STATE OF NORTH CAROLINA
DEPARTMENT OF TRANSPORTATION

May 31, 2007

Subject: Modification to 404 Individual Permit No. 200520314
Modification to 401 Individual Permit No. 05-0061
TIP # R-3415
Widening of NC 67 from Jonesville to Booneville
Yadkin County, North Carolina
WBS: 34541.3.2 (DWQ Permit Fee: \$475)

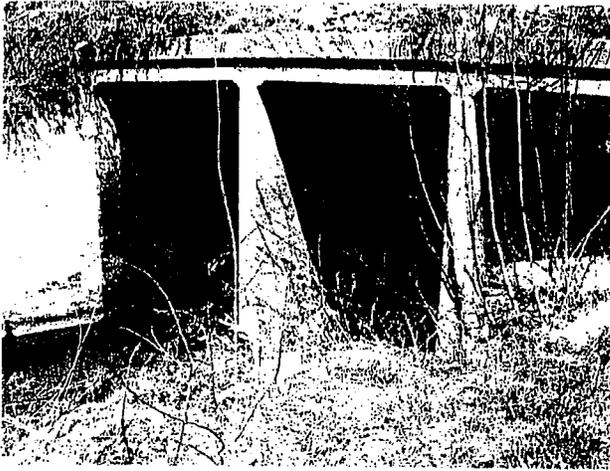
1. Inlet view of Site #1 culvert. Note that base flow is not isolated to one barrel and a high right bank is preventing most stormwater flow from entering the easternmost barrel.
2. Outlet view of Site #1 culvert. A floodplain has formed behind the base flow barrel instead of behind the stormwater barrels. We will correct this situation with appropriate floodplain construction on the inlet and outlet sides of this culvert.
3. Site #1 downstream view.
- 4-6. Photos of UT to Lineberry Creek east of the Site #1 culvert location.

This triple barreled 9'x15' RCBC will be extended a total of 24'. Adding concrete sills to both stormwater barrels will isolate base flow to the western barrel. This will increase base flow depth inside of the culvert and will improve aquatic life passage during periods of low flow. Floodplain construction will provide the

We are proposing to place the inlets of all three barrels at grade (there is no need to bury the silled stormwater barrel extensions and this should prevent a head cut in the base flow barrel). The base flow barrel outlet will be placed at grade as well.

As a result of the overestimated culvert extension length and the onsite improvements listed above, it is requested that offsite mitigation associated with this culvert extension be reduced from 32' down to 0'.

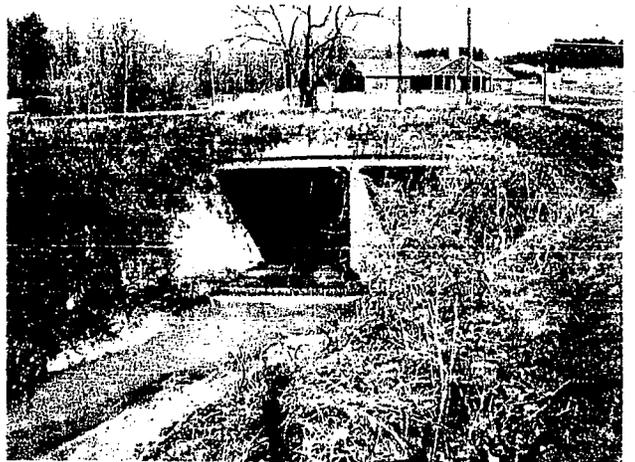
7. Inlet view of Site #2 culvert.
8. Outlet view of Site #2 culvert. Note that flow is not isolated to the base flow barrel and the culvert is perched. We will be correcting this situation as well as constructing floodplains.
9. Williams Creek just upstream of the Site #3 culvert. This stream has already been relocated away from this slope failure and retaining wall.
10. Williams Creek at the Site #3 culvert inlet. Due to the relocation, the concrete slabs no longer armor this streambank. A floodplain will be created in front of the eastern barrel to reduce water velocity in the base flow barrel during storm events.
11. View of UT to Williams Creek entering the Site #3 culvert.
12. Site #3 culvert outlet is perched. We will be correcting this situation as well as constructing a downstream floodplain.

This culvert is also perched. We will construct the outlet extension with the proposed 1' drop and add a sloped concrete floor in the base flow barrel. A concrete sill will be added at the end of the base flow barrel outlet extension up to the natural streambed elevation at that location. I do not believe that will cause the entire culvert to back fill with natural stream material but do think that will help reduce scour at

the outlet since the extension will be on a > 10% grade due to the existing perched condition. We will place the inlets of all three barrels at grade.

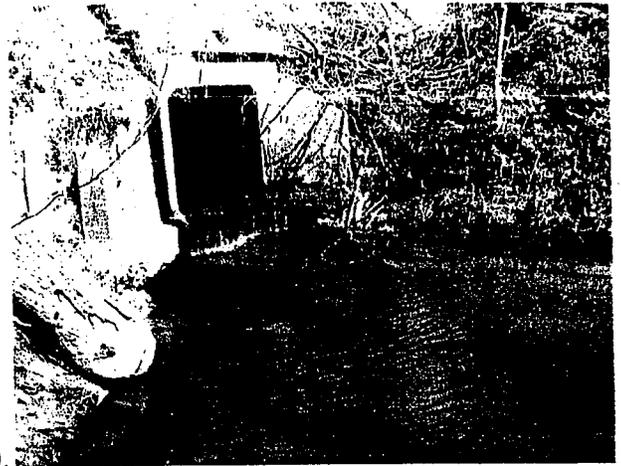
19. Perched culvert outlet at Site #7. As mentioned in the letter, the pipe extension will be placed at grade to reduce the slope of the extension.
20. Perched culvert outlet at Site #9. As mentioned in the letter, the pipe extension will be placed at grade to reduce the slope of the extension.
21. Site #10 culvert inlet.
22. Perched culvert outlet at Site #10. As mentioned in the letter, the pipe extension will be placed at grade to reduce the slope of the extension.

This 4' x 5' RCBC will be collared and extended a total of **44'** with 60" RCP. This culvert is also perched. For reasons previously stated, we plan to place the inlet and outlet of this culvert at grade.

This 4' x 4' RCBC will be collared and extended a total of **68'** with 54" RCP. This culvert is also perched. As with several of the other sites, we plan to place the inlet and outlet of this culvert at grade since that appears to be the most logical alternative.

This 3' x 4' RCBC will be collared and extended a total of **92'** with 48" RCP. This culvert is also perched. Again, due to existing site conditions, we plan to place the inlet and outlet of this culvert at grade.
